LIDO 14 CLASS ASSOCIATION

APPROVED CHANGES and DISALLOWED CHANGES

Revised August 2025

Lido 14 Mast Preventer

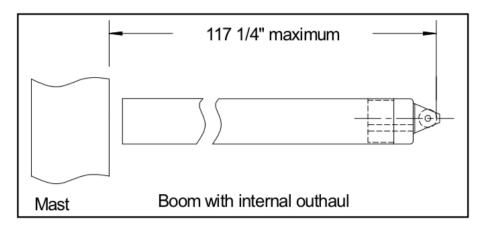
- 44. A mast preventer may be rigged between mast and shrouds.

Approved Change # 44

Measurement of boom maximum length with sheave at aft end for internal outhaul per Approved Change 73

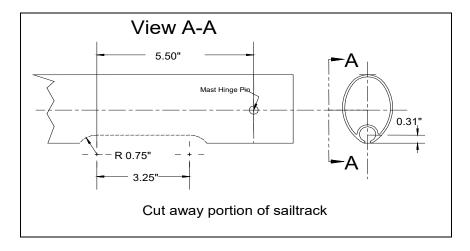
- 72. May 2001: The "Classic Lido" mast butt fitting is allowed for use on all Lido 14s.
- 73. July 2001: A roller fitting (Ronstan RF 453 or equivalent) may replace the stock cast boom end fitting and be attached to the end of the boom to guide a single outhaul line from the clew of the mainsail either around or to the inside of the boom. Blocks and line may be attached to the outhaul in any combination to gain mechanical advantage. The angle of the line from the clew to the end of the boom must be essentially the same as with the stock factory fitting, and all rigging must be within or attached to the boom.
